MIL-L-3661/64C
AMENDMENT 3
12 September 2003
SUPERSEDING
AMENDMENT 2
17 June 1987

MILITARY SPECIFICATION SHEET

LAMPHOLDER, LIGHTS, INDICATOR (HOUSING), STYLE LH97

Figure 1. Style LH97 housings.

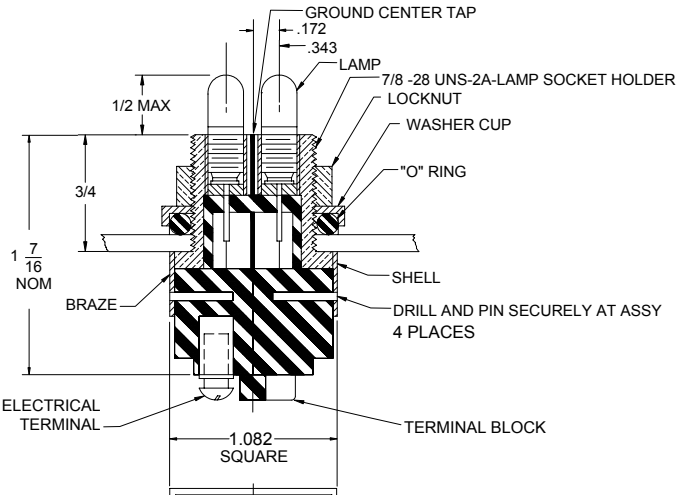
FIGURE 1: Delete and substitute:

FIGURE 3. Midget screw lamp socket.

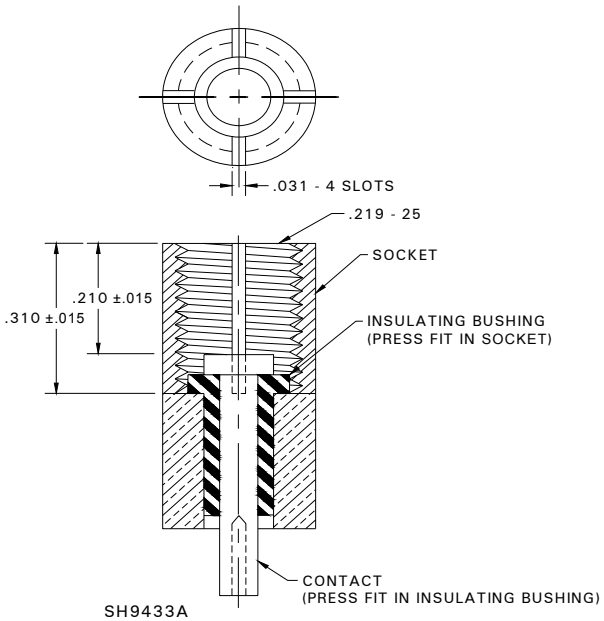
FIGURE 3: Delete and substitute:
